STAFF REPORT

Type III - Site Plan Review

SUBJECT PROPERTY: 520 Lindy Lane, Coos Bay, OR 97420 (25-13-21CB – Tax Lot 5901)

APPLICATION: SITE PLAN REVIEW #187-ZON17-082
One-story 7,153 square foot dialysis medical facility

SHEET 4 OF 5

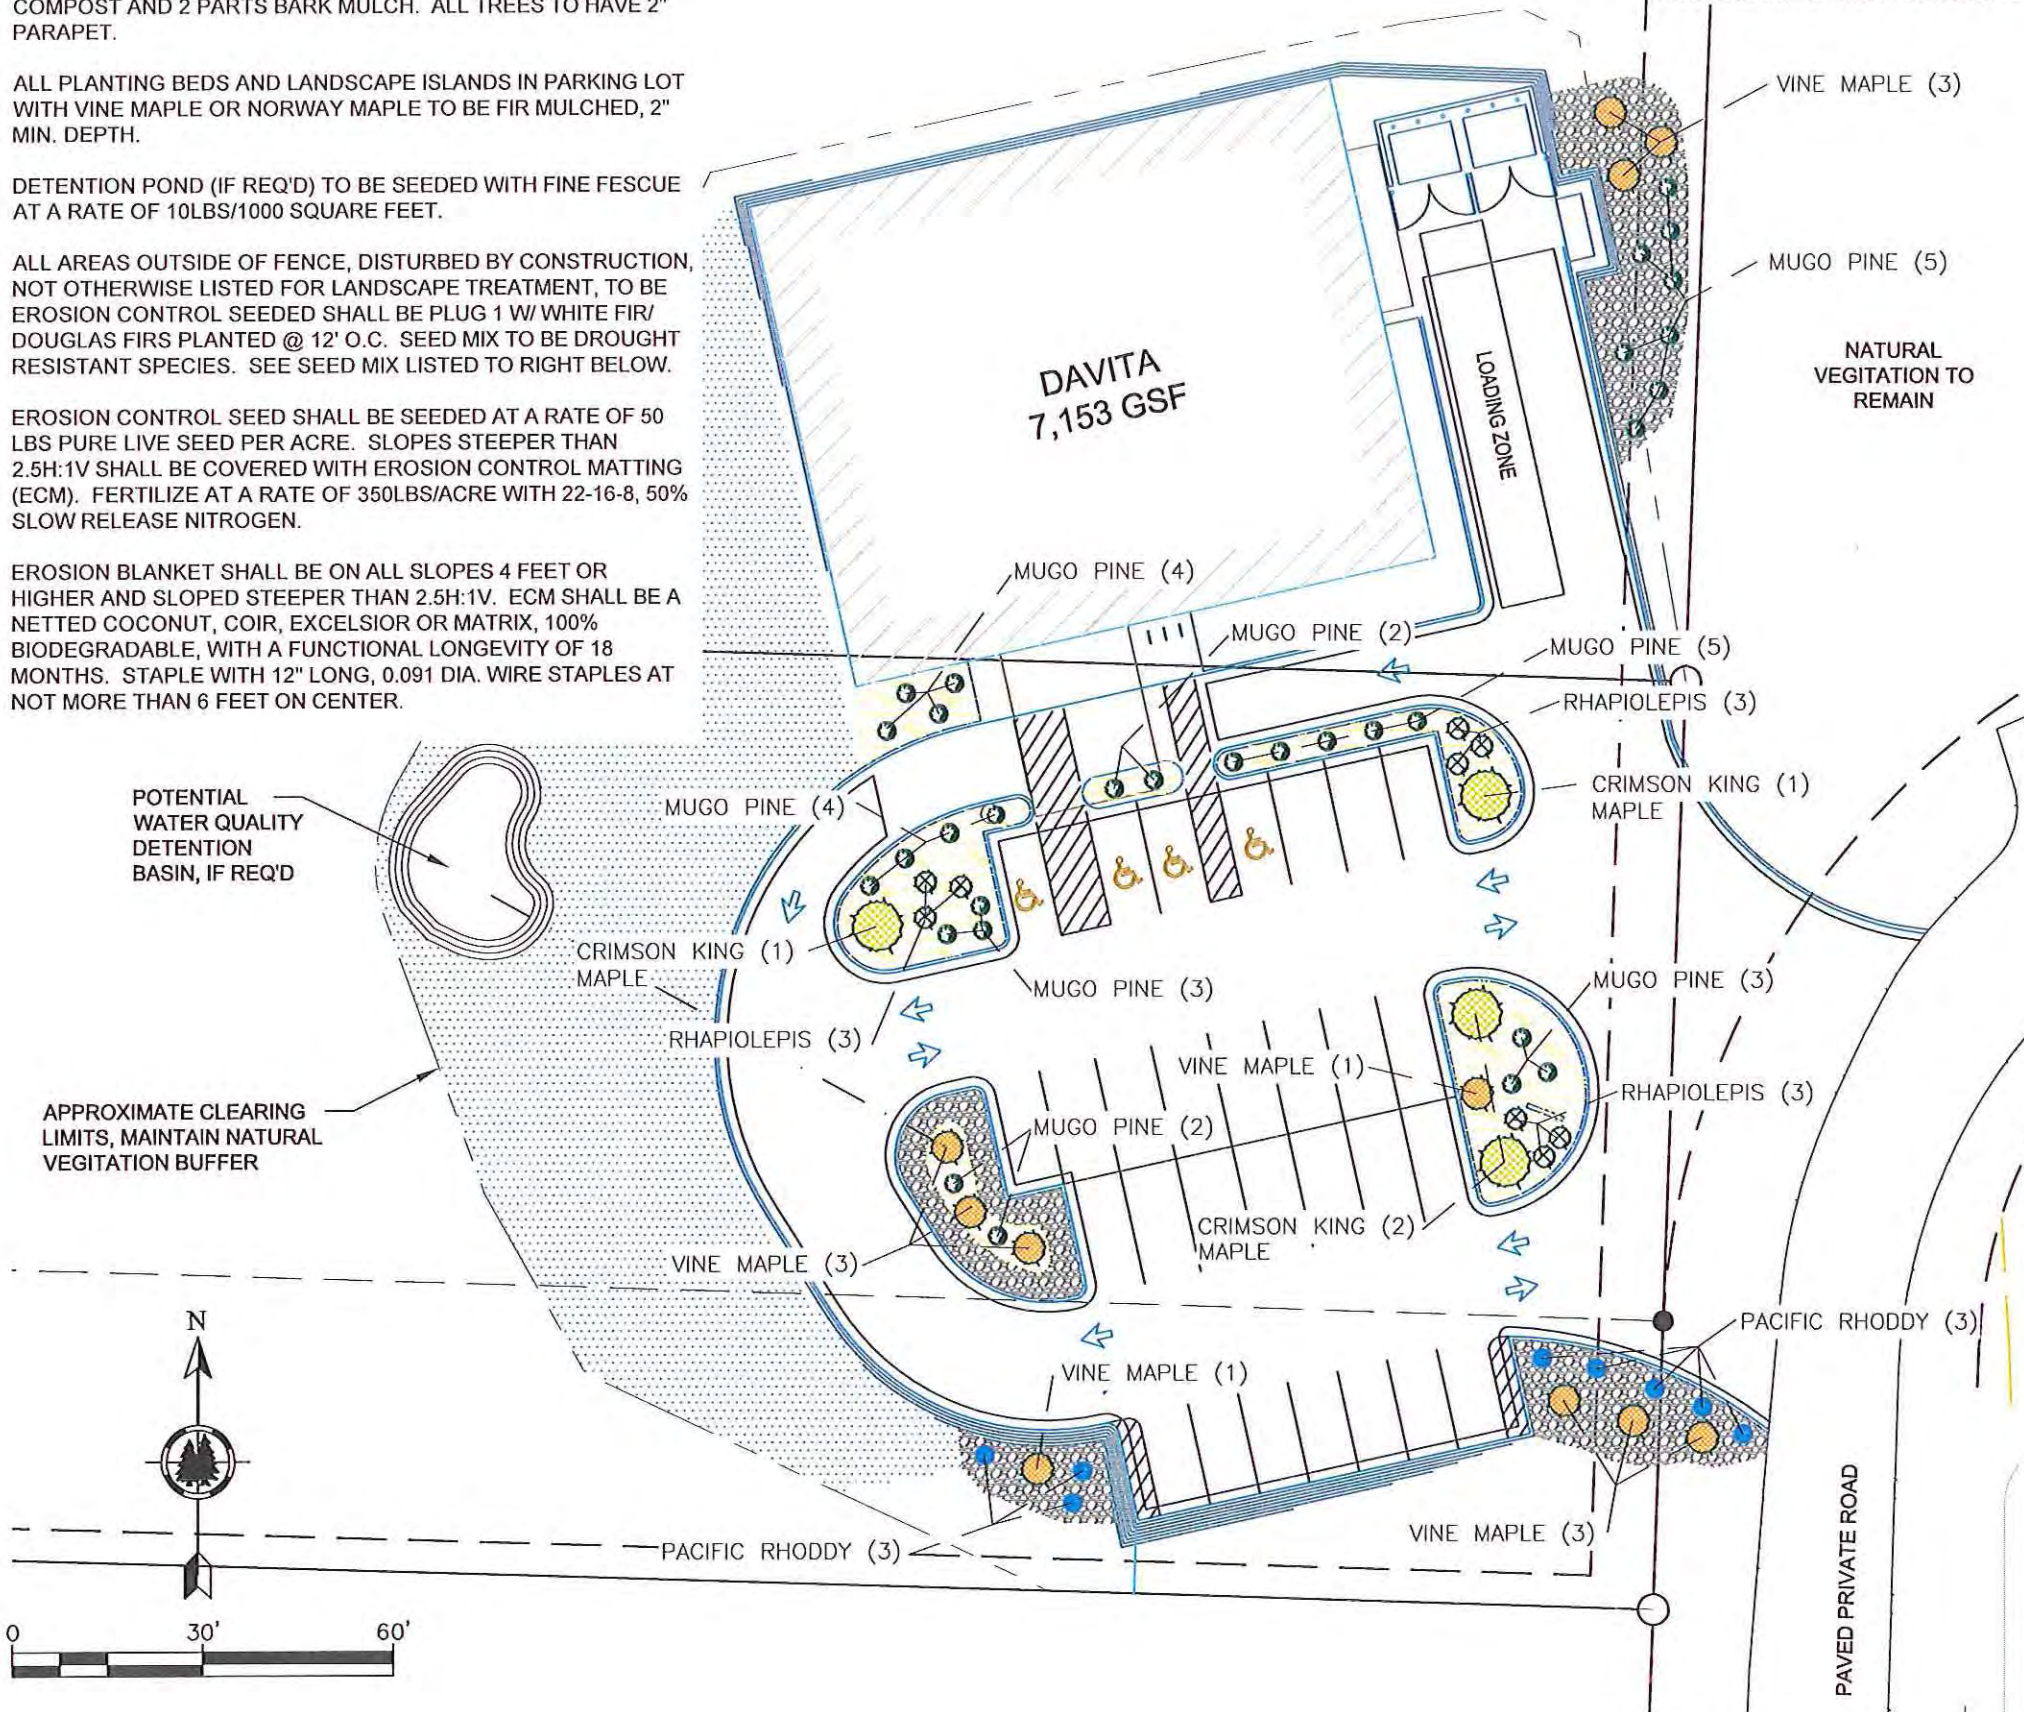
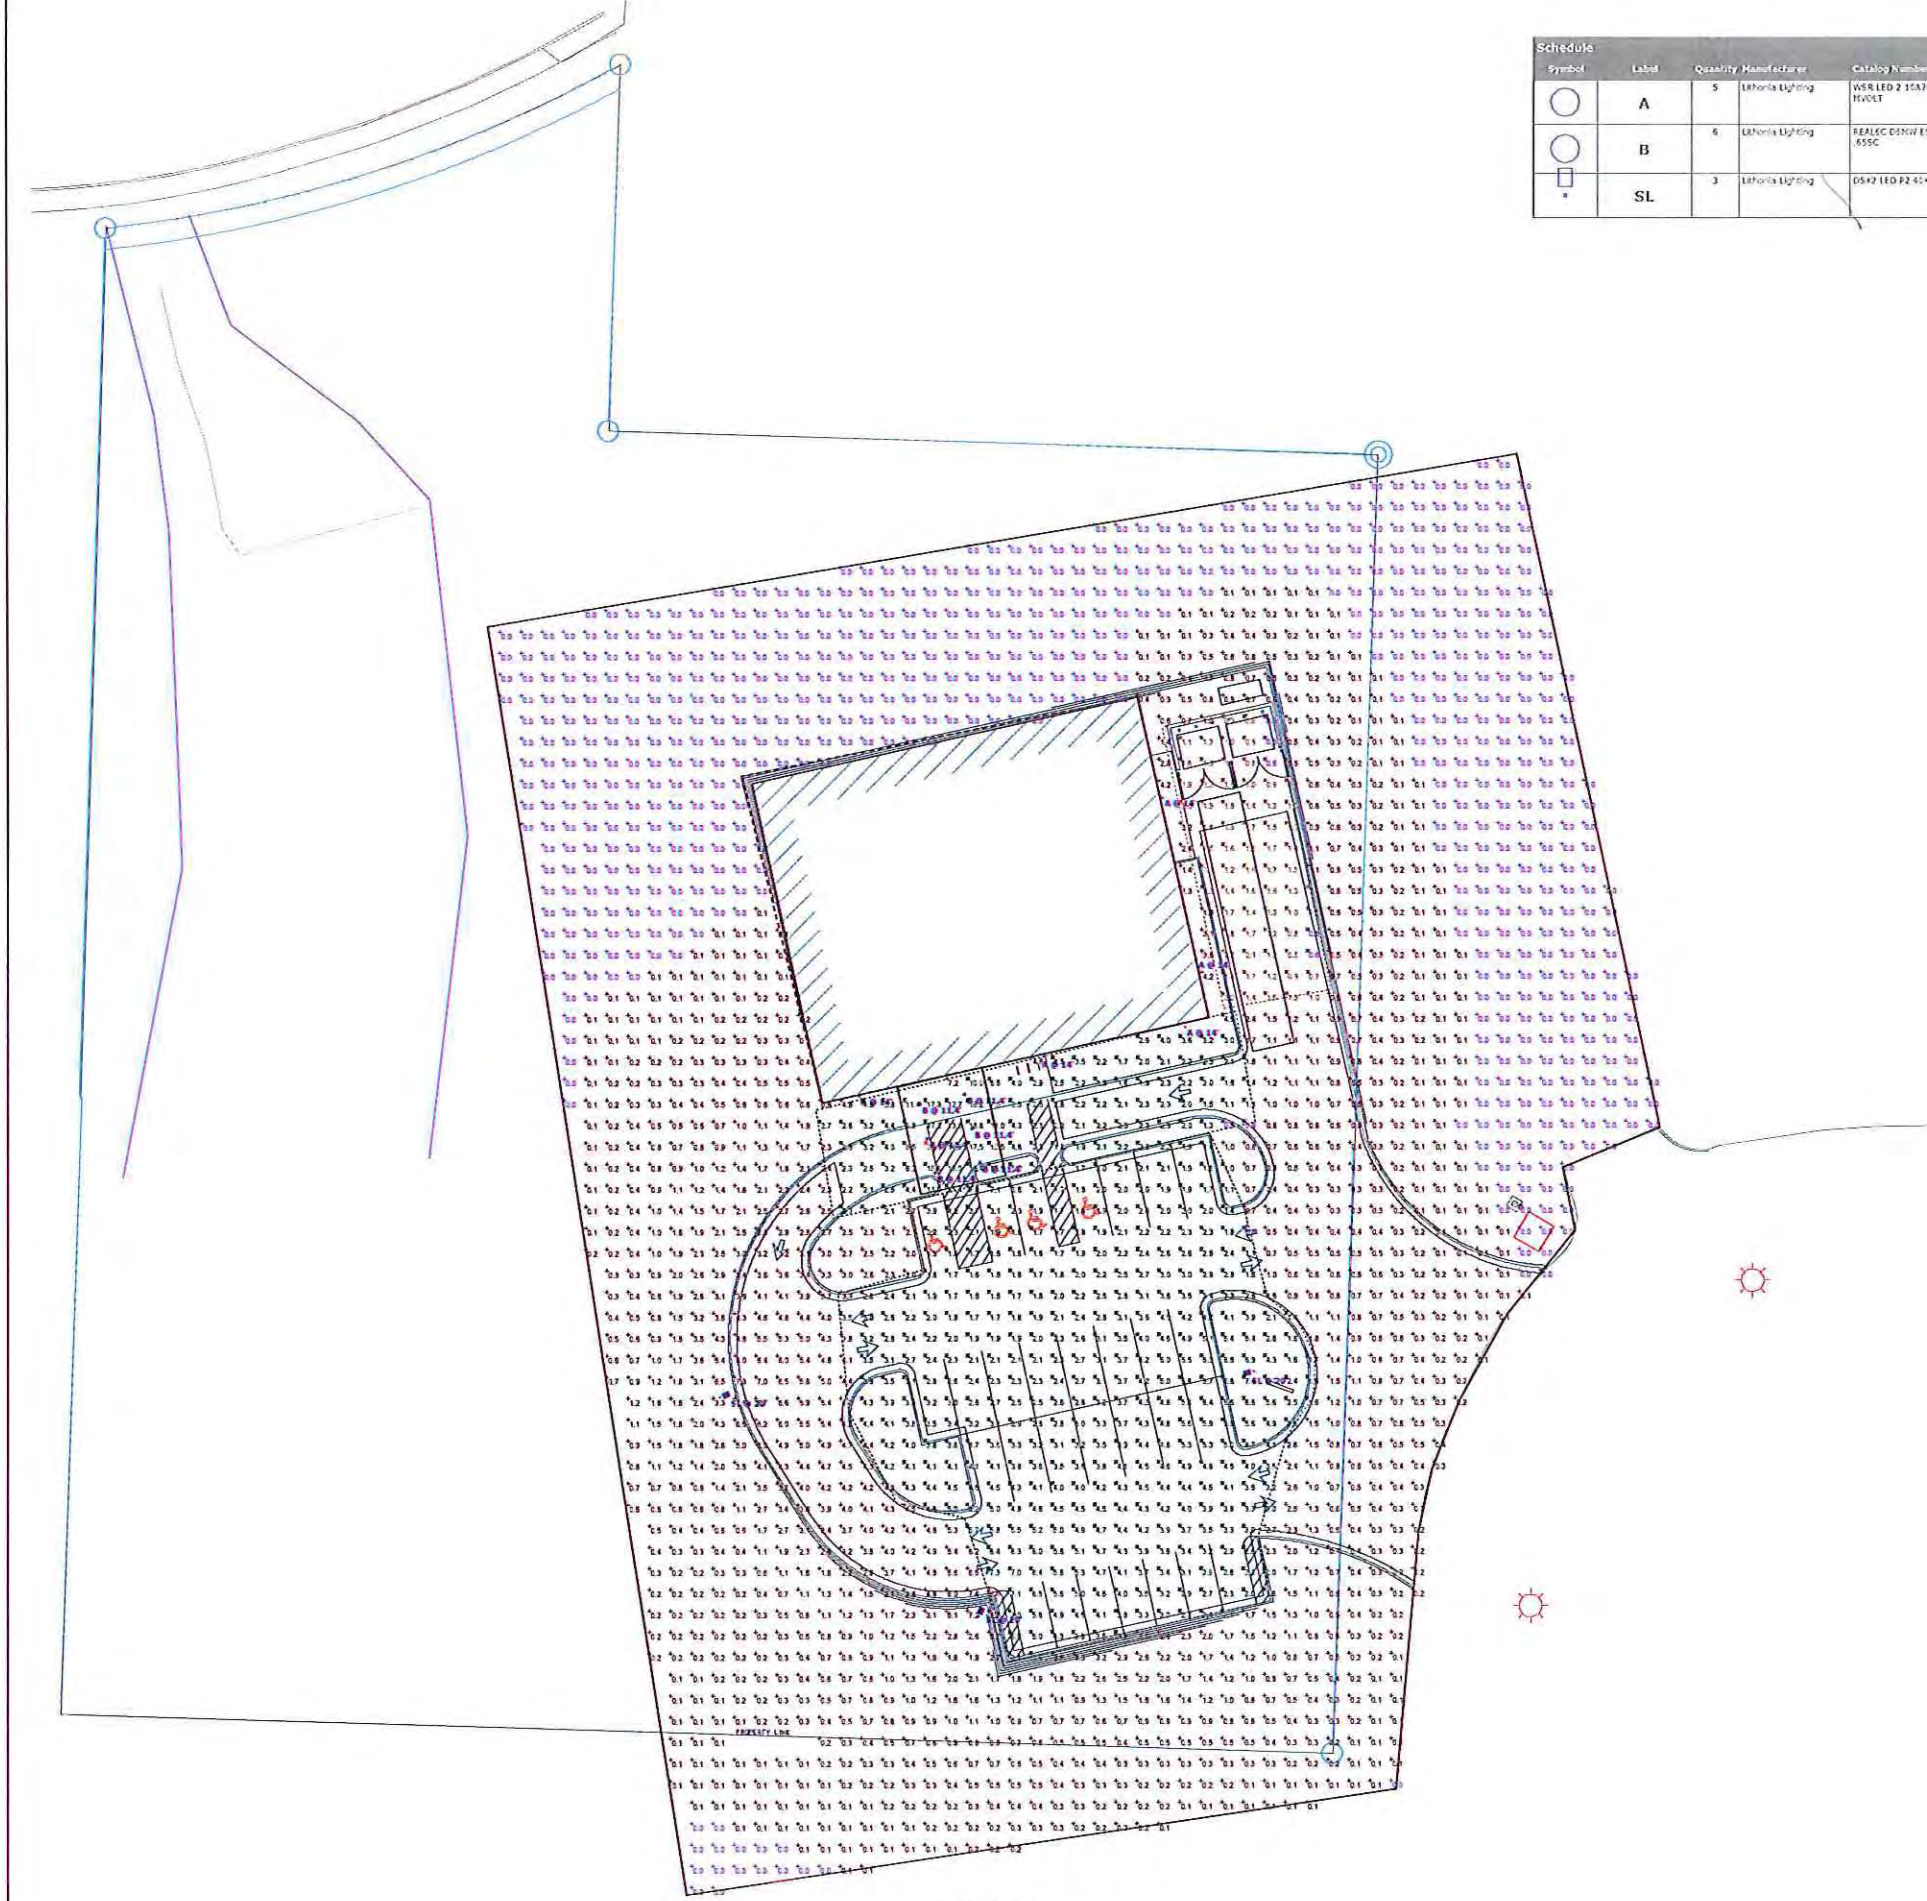
According to the submitted landscape plan only 2 percent of the site will be landscaped. Prior to the issuance of permit, the applicant must show compliance with the minimum required landscaping of 15 percent of the lot, which can include existing vegetation.

The applicant has provided a landscape plan for the proposed development that did not include existing vegetation.

The submitted site plan indicates one 60-foot and 24-foot loading zone will be provided; Therefore, an adequate loading/unloading area has been provided (See applicant's submittal "Sheet 4 of 5").

1. Exterior lighting must comply with CBMC 17.362.040 Lighting.
2. Prior to the issuance of permit, the applicant must show compliance with the minimum required landscaping of 15 percent of the lot, which can include existing vegetation.
3. Any Water quality detention feature must be approved by the Engineering Department prior to issuance of development permits.

PROJECT # 2017.2477.00
SHEET # **A-201**

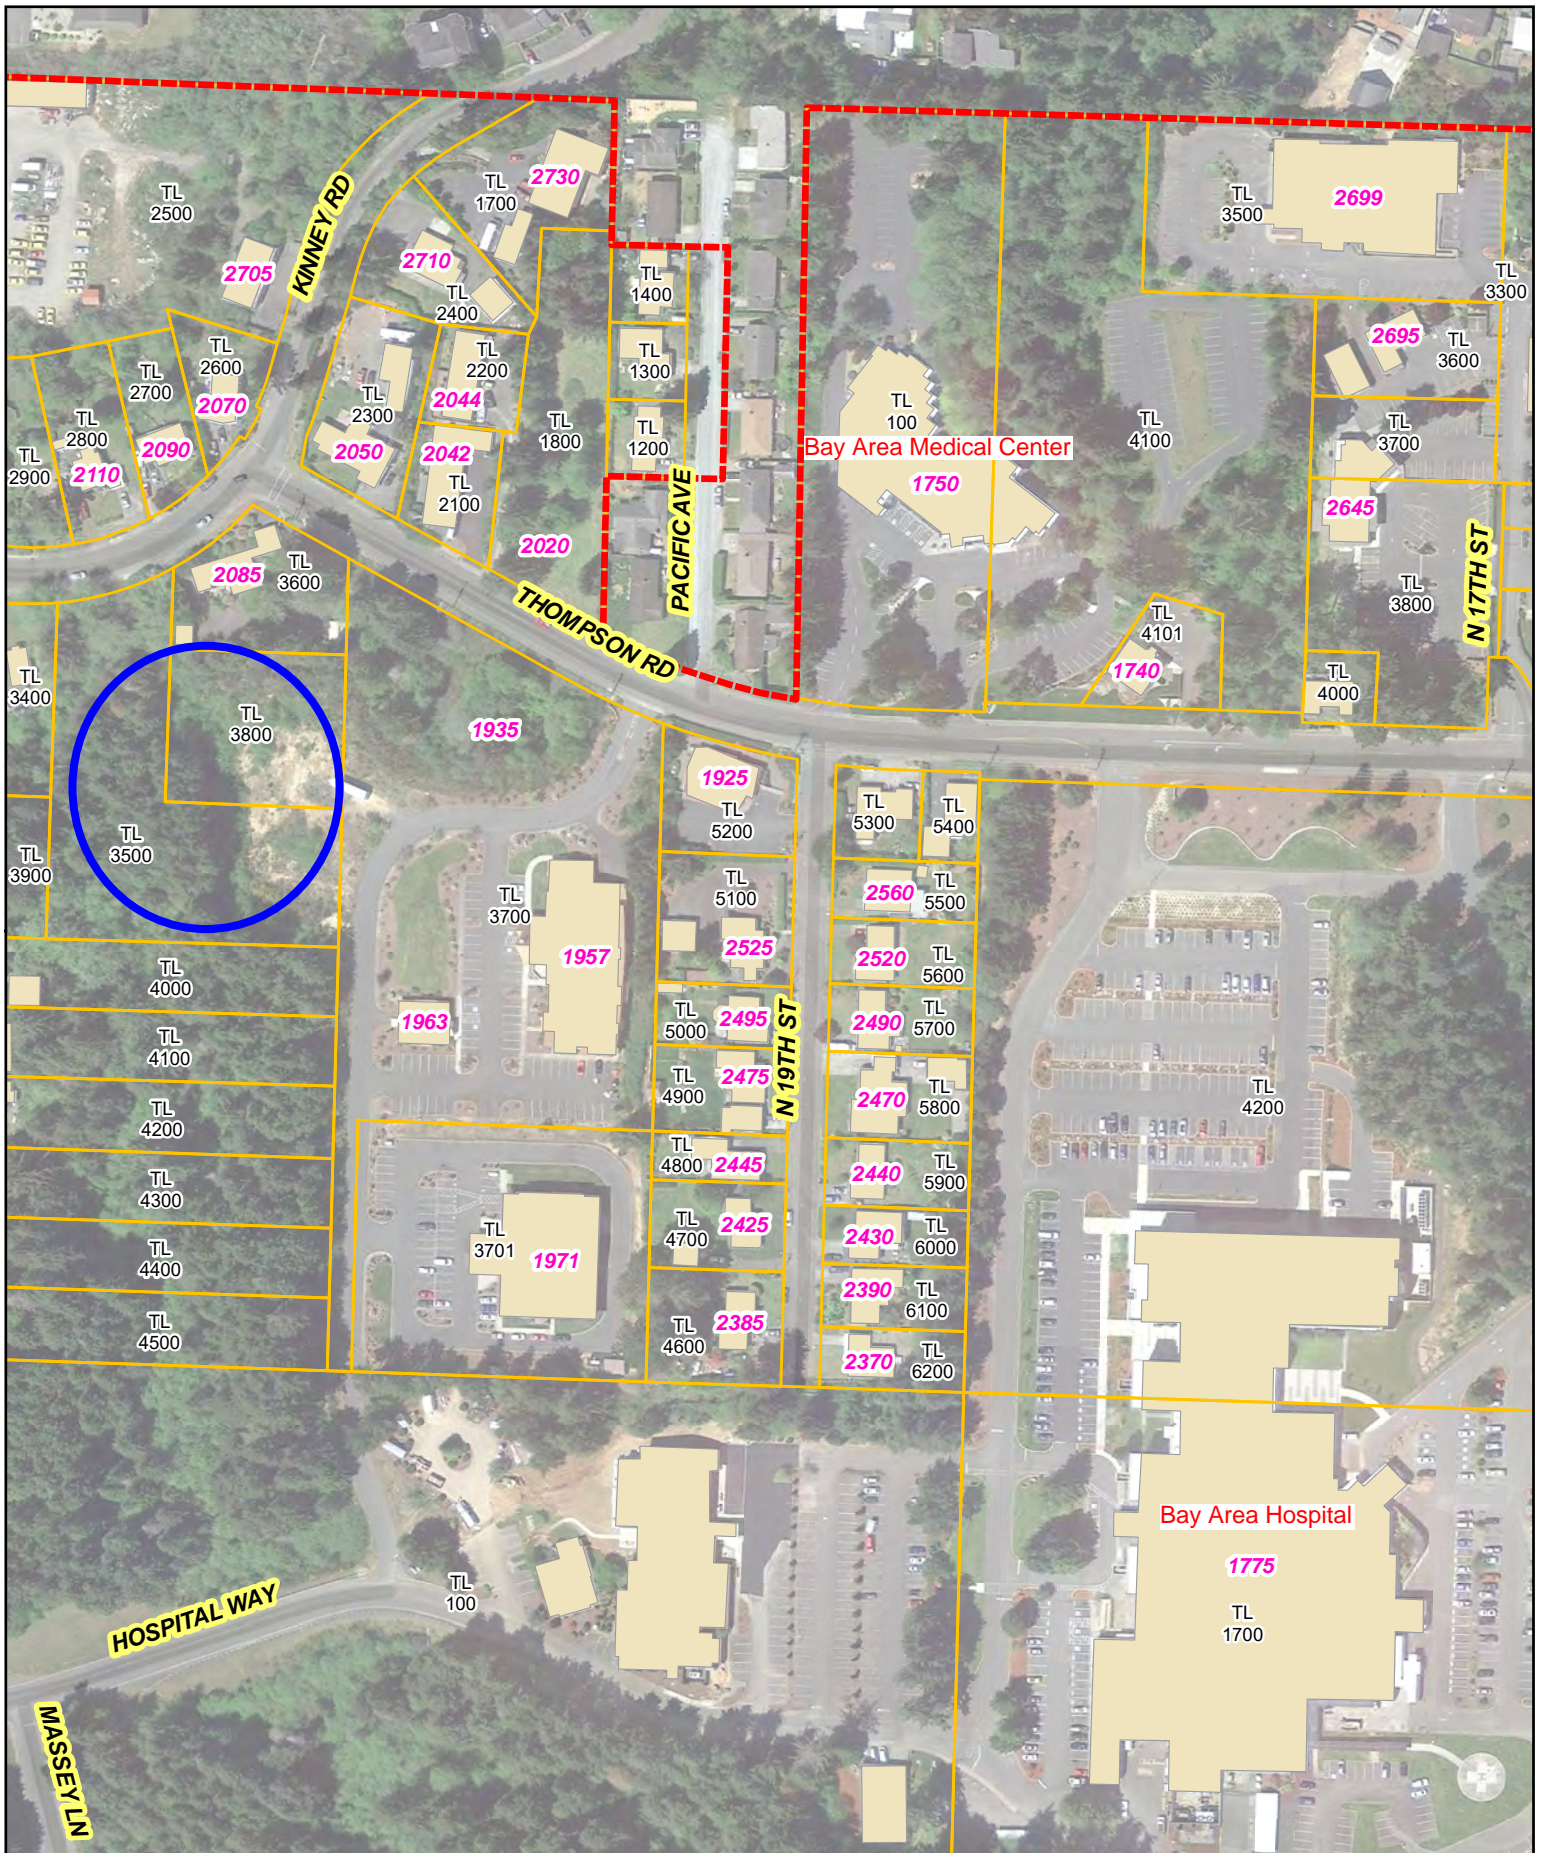
The heating and air equipment will be roof mounted equipment and not visible to the public and the proposed storage and trash area is fenced and screened from public view (as shown on page A-201 & A-202).
